## WARRANTY BULLETIN

Wb10-13

| SUBJECT : OVERHEATING OF HALOGEN LOW BEAM HEADLIGHT CABLE CONNECTOR |                           |

FIGURE 3: LOW BEAM AND CONNECTOR

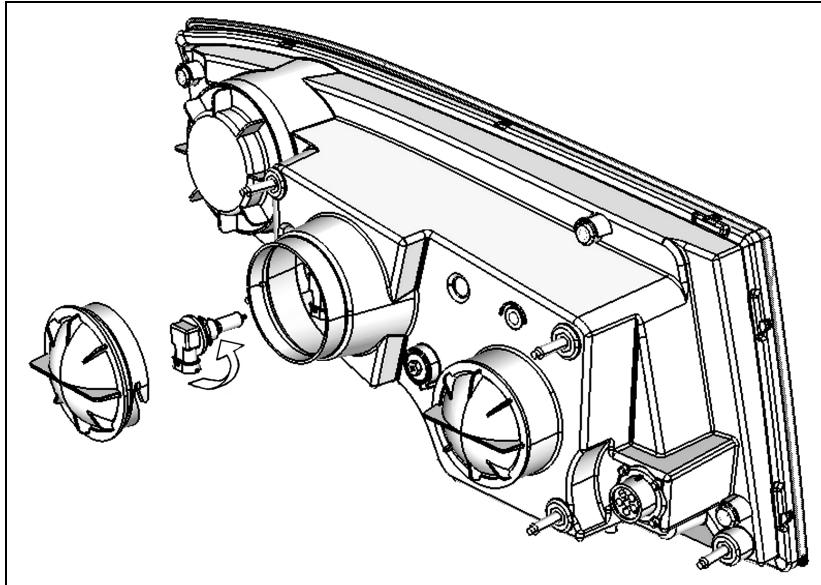
On the vehicles affected by this bulletin, there is a risk that the low beam electrical connector overheats; which may prevent the low beam headlights from being used.

4. Unscrew the low beam access cap to gain access to the bulb connector.

5. Turn the bulb base counterclockwise (figure 3).

6. Separate connector from bulb base.
